UNITED STATES PATENT AND TRADEMARK OFFICE

APPLICATION NO.	FILING DATE	FIRST NAMED INVENTOR	ATTORNEY DOCKET NO.	CONFIRMATION NO.
10/615,133	07/08/2003	Mary Morabito O'Neill	02W234	8119

Office Action Summary

DETAILED ACTION

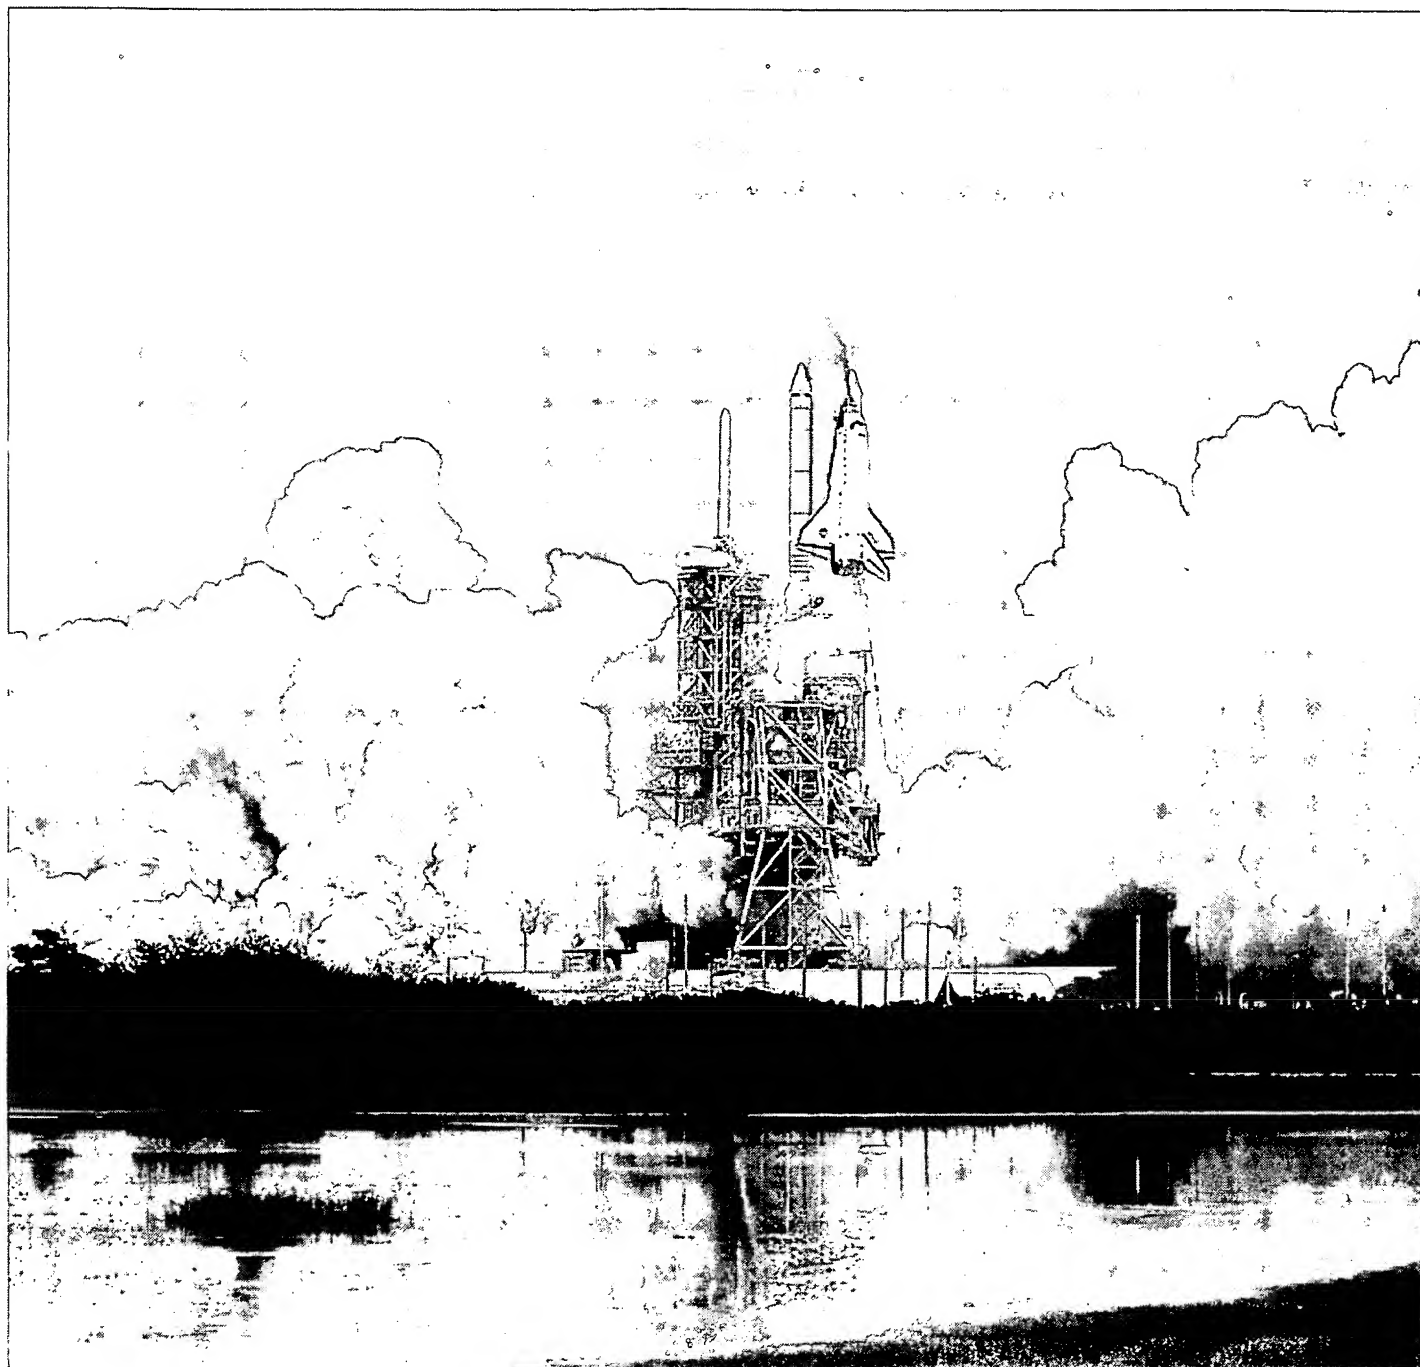
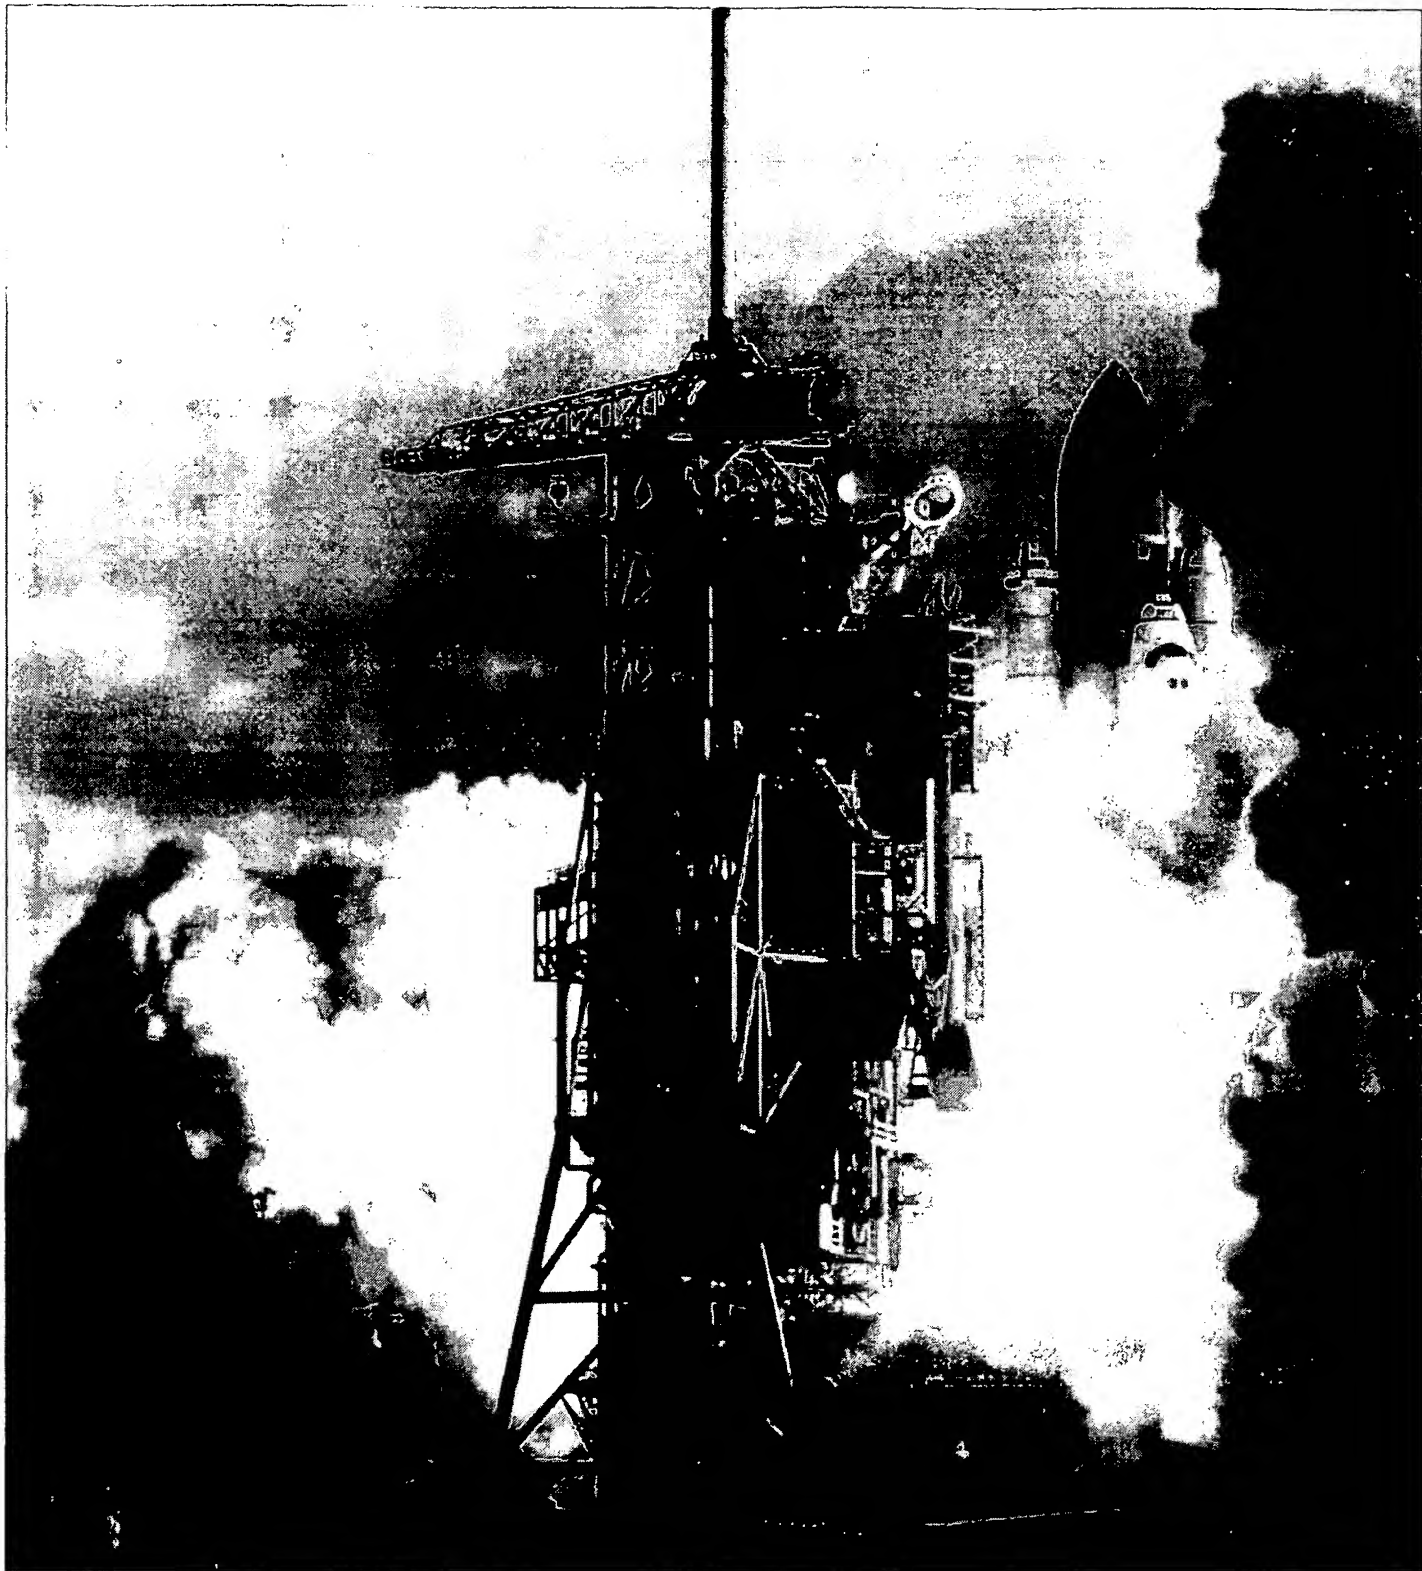
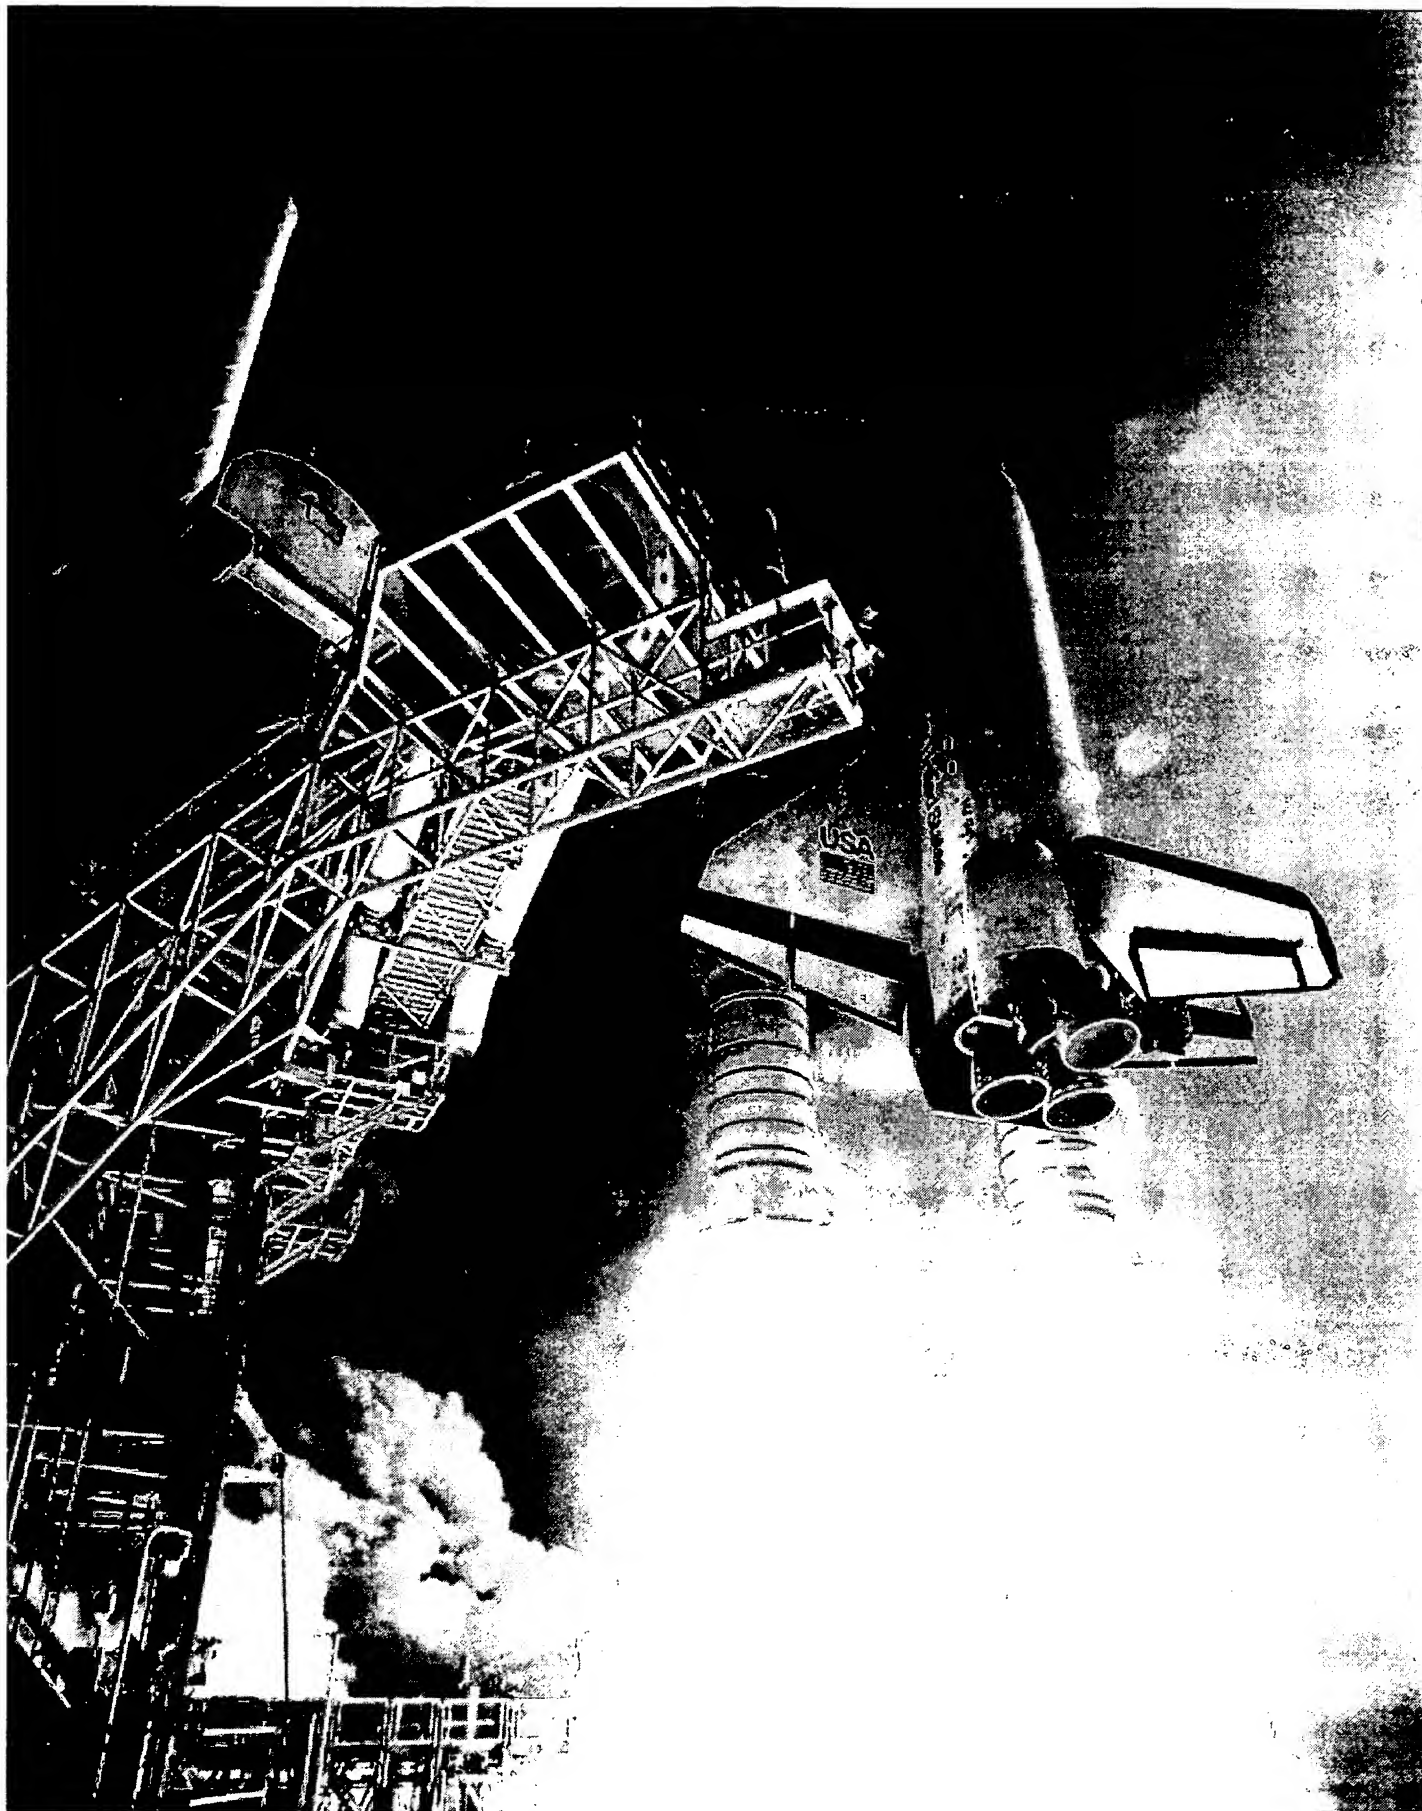
hydrogen, liquid oxygen and solid propellant (See any one of "Space shuttle main engine biography", "Solid Rocket Boosters", "How Space Shuttles Work" and "Space shuttle main engine"). At T minus 0 seconds the SRBs engines ignite the "source" of obscurant comprising solid propellant. As shown in the photos below, the shuttle is riding on a plume having a temperature greater than 150 degrees Celsius and is followed by great clouds of exhaust material, said exhaust inherently including traces of carbon dioxide and water vapor having a temperature less than that of the plume. As shown below, a viewer directly below or to the side of the shuttle during launch would have its view (infrared or otherwise) obscured by the clouds of obscuring agent.
